## ITEM REPORT PLANNING AND ZONING COMMISSION

**REQUEST:** **PUBLIC HEARING. Preliminary and Final Plat** to allow “Timberline Heights Second Addition” to create one buildable lot; **Comprehensive Plan Amendment** from Public/Semi-Public/Institutional to High Density Residential; **Rezoning** from OS, Office Service to R-3, High Density Residential; and **Variance** for roof pitch for a 60-unit Apartment for property located at the southwest corner of Clearwater Road and Forest Drive (City File # 2026-023)

**APPLICANT:** Kuepers Inc.

### *Existing Future Land Use*

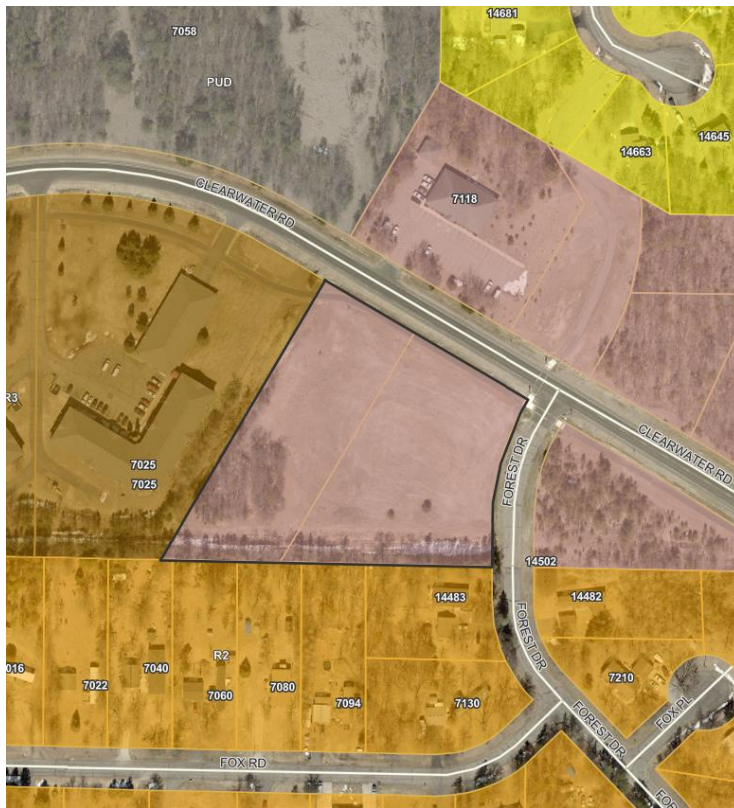
The applicant is requesting a Comprehensive Plan amendment to re-designate the underlying land use guidance for the east side of the site from Public/Semi-Public/Institutional to High Density Residential. As you can see from the Existing Future Land Use Plan below, the westerly lot of the site is already guided High Density Residential. The Public/Semi-Public/Institutional guiding was established at a time when the city was holding this property for a potential fire station, which is no longer planned.

The existing Future Land Use Plan includes a large block of high-density residential land use on the south side of Clearwater Road. The amendment would complete this block from Grand Oaks Drive to Forest Drive as High Density Residential. Future Land Use to the North and East is Office and High Density. This land use would transition across the site to medium density and low density to the south, southeast and southwest.

Staff finds that proposed land use amendment would provide an appropriate transition of land use to surrounding properties. Staff notes that although the property to the south is guided for medium density residential, the property is developed with single family homes. As such the development

should focus on site specific transitions between the apartment development and the single-family homes to the south. The developer is leaving a 35-foot easement buffer, to support this transition. Additionally, the developer has oriented the building to the east and north to the extent possible and is proposing pine trees to soften the transition to single family to the south.
